REMARKS/ARGUMENTS

Amendments to the Drawings:

ANNOTATED MARKED UP DRAWINGS SHEET

FIG. 1

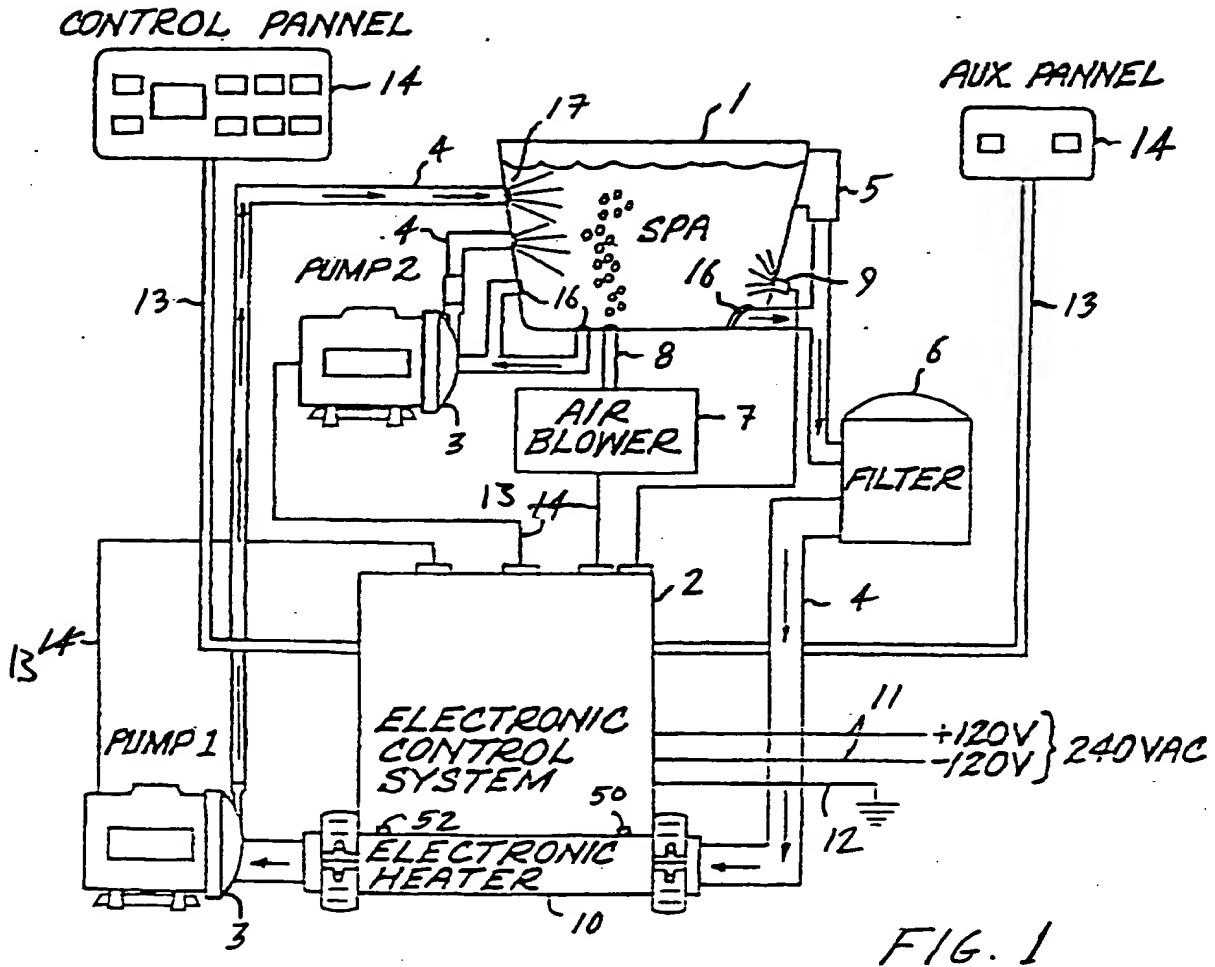
Applicants respectfully request that the Examiner enter the amendment to Figure 1. The "cables" have been relabeled as reference number 13. The amendment is supported in the specification at least at Page 7, line 30 through Page 8, Line 2.

The attached Replacement Sheet of drawings includes changes to Fig. 1. This sheet, which includes Fig.1, replaces the original sheet including Fig. 1. In Figure 1, previously mislabeled "cables" connecting the electronic control system 2 to the air blower 7 and pumps 1, 2 have been changed from the incorrect number 14 to the correct number 13. The attached Annotated Marked-Up Drawings sheet indicates the changes made.
